RESOLUTION SETTING HEARING ON REQUEST FROM 50TH AND DOUGLAS, LLC TO REZONE PROPERTY IN THE VICINITY OF 3905 50TH STREET

**Legal Description, Property in the Vicinity of 3905 50th Street – 50th and Douglas
LLC (ZON2018-00137) – Hearing: September 10, 2018**

Communication from the City Plan and Zoning Commission advising that at their August 2, 2018 meeting, the following action was taken regarding a request from 50th and Douglas, LLC (developer), represented by Matt Connolly (officer) to rezone property located in the vicinity of 3905 50th Street from "R1-60" One-Family Low-Density Residential District to "PUD" Planned Unit Development for development of 21 row house 1-story townhomes on a private drive accessed from 50th Street. Subject property is owned by Penny Meyer and Jerry Lohner.

STAFF REPORT TO THE PLANNING COMMISSION

SHEET 2

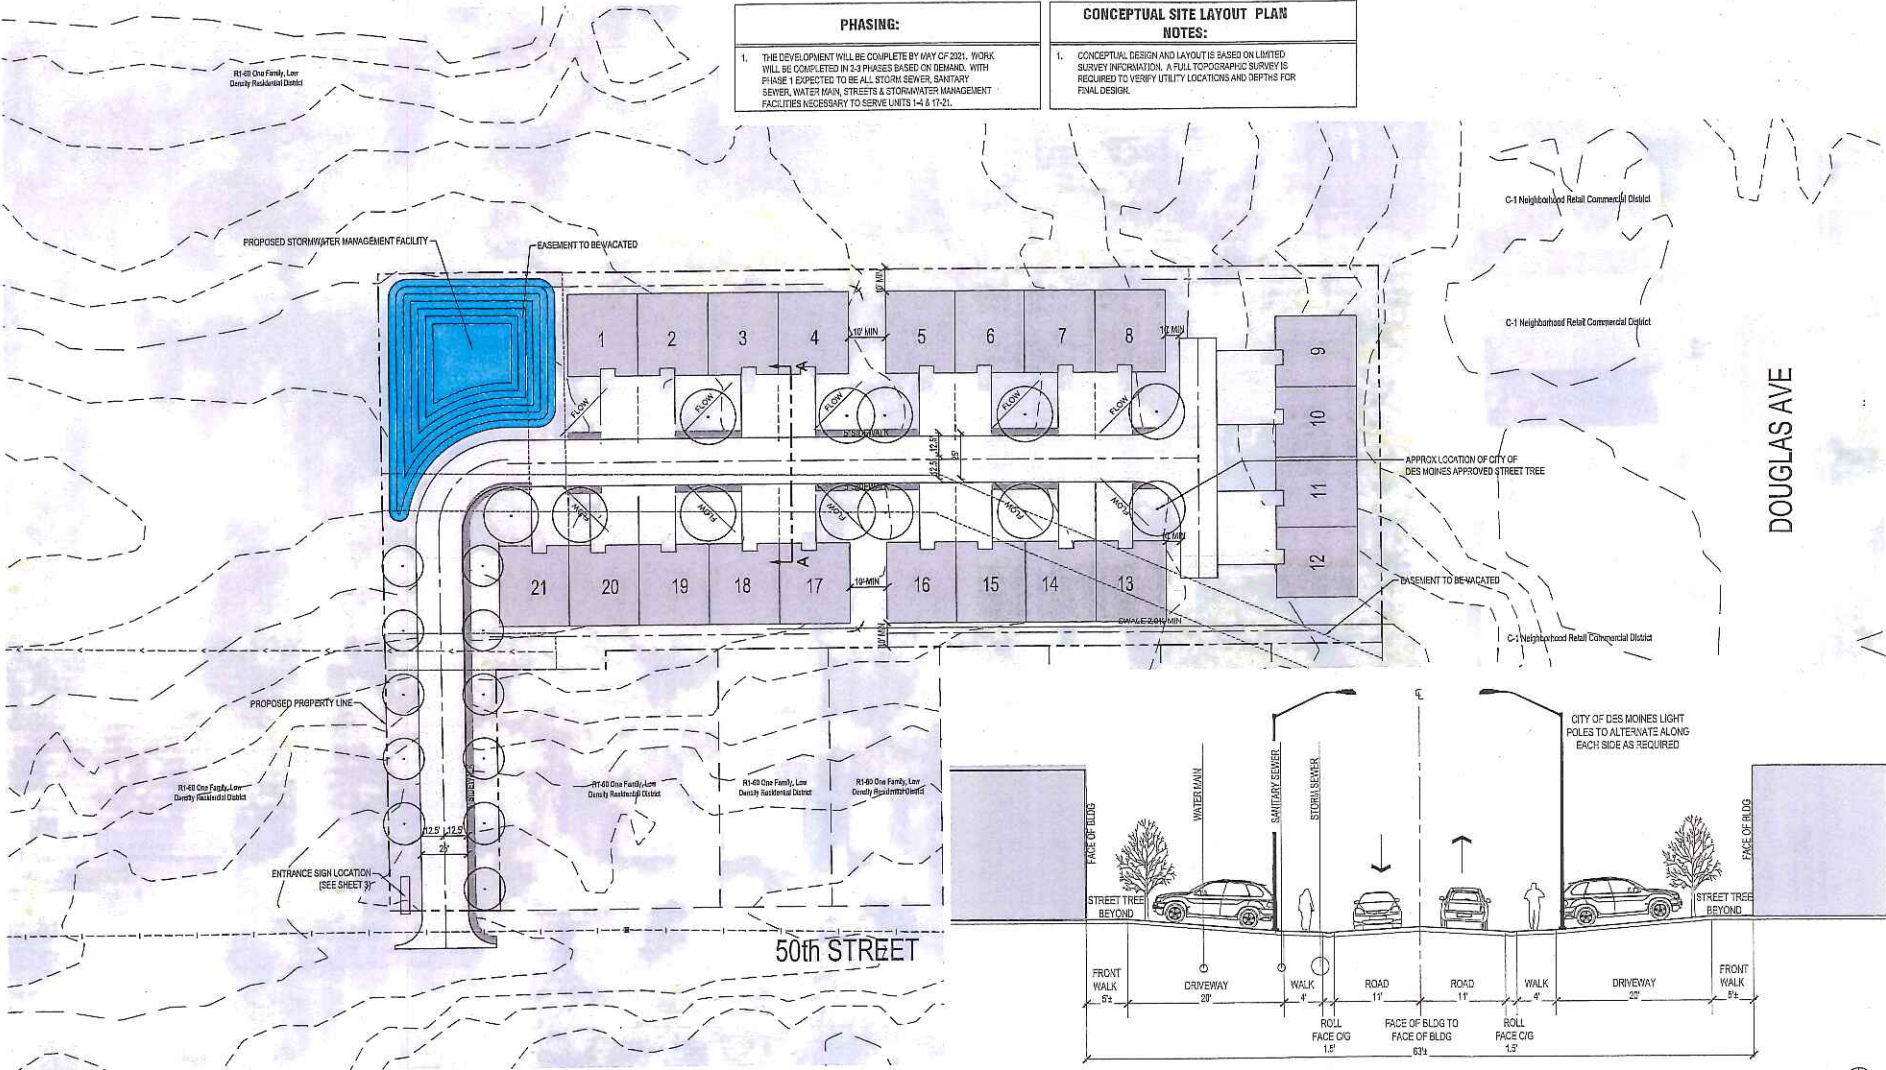
The PUD Conceptual Plan includes a storm water basin in the northeast corner of the development. A swale is noted along the west perimeter of the development to move storm water to the basin. Staff believes that raingardens should be provided along the access drive to capture run off from the pavement and roofs of the buildings as well as to soften the high percentage of pavement and rooftops that are proposed for the development. Section III of this report includes the recommendation that the sidewalks be separated from the access drive a distance of at least 4 feet and that raingardens/swales be provided in that space.

- *This concept plan indicated existing public storm sewer will be relocated with existing easements being vacated. New public storm sewer locations on private property will need to be within a 30-foot minimum easement.*

- *The concept indicates “swales” along the east and west property lines within a 10-foot minimum setback. A 10-foot width is very small for a grassed swale with this size of drainage area. The designer will need to provide evidence that swales can convey 100-yr storm event.*

12. Raingardens, bio-swales, landscaping and/or detached sidewalks shall be provided to visually break up paved surfaces through the center of the development to the satisfaction of the Planning Administrator.

CONCEPTUAL STREET SECTION (A)

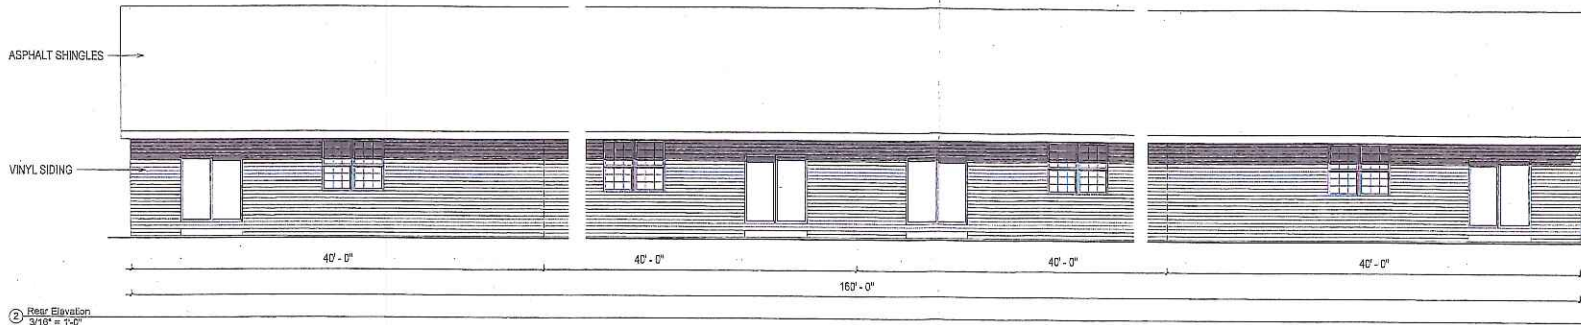
Mike Simonson stated he would like to see the sidewalk separated from the curb to provide some green space. Only requiring sidewalk on one side of the street would allow the provided sidewalk to be detached from the curb.

23. A 4-foot detached sidewalk shall be provided on the west side of the private drive only.

1 Front Elevation
3/16" = 1'-0"

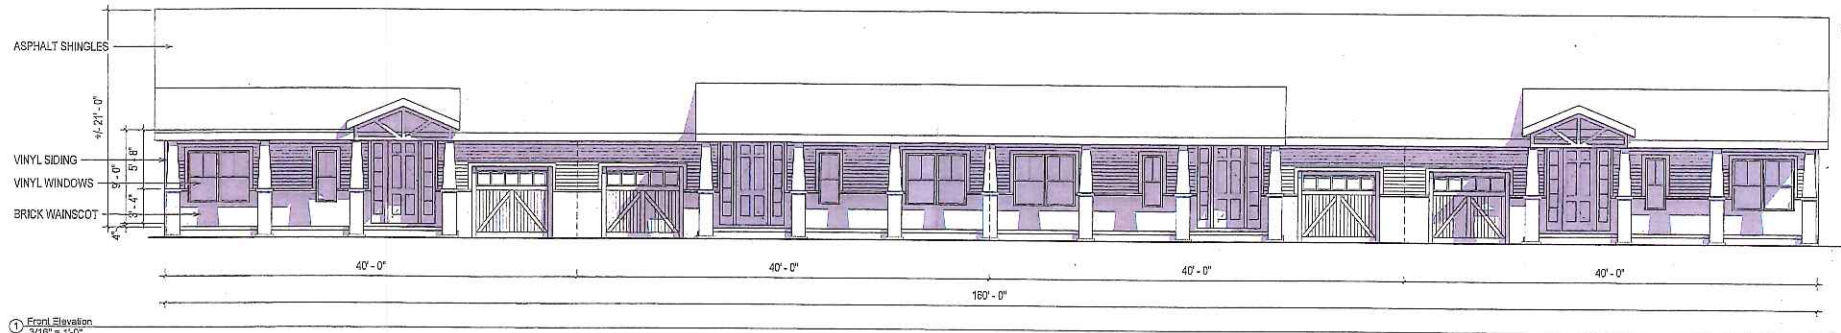
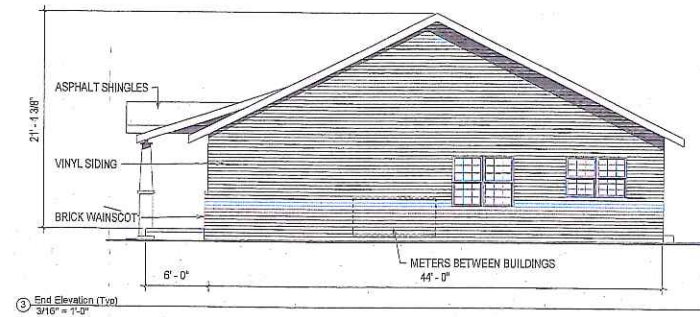
2. Siding shall consist of masonry, fiber cement board, wood or engineered wood. The use of vinyl siding is prohibited.
3. A brick wainscot shall be provided along the front facades of all buildings and along external facing side facades (Units 1, 8, 9, 12, 13 and 21).

4. The brick wainscot required by condition #3 shall extend a minimum of 4 feet along the interior side facades from the front of the building (Units 4, 5, 16 and 17).

7. A rectangular vent element shall be provided in the gable ends of the buildings.
8. Overhead garage doors shall include windows.
9. All dwelling units shall have architectural asphalt shingles.
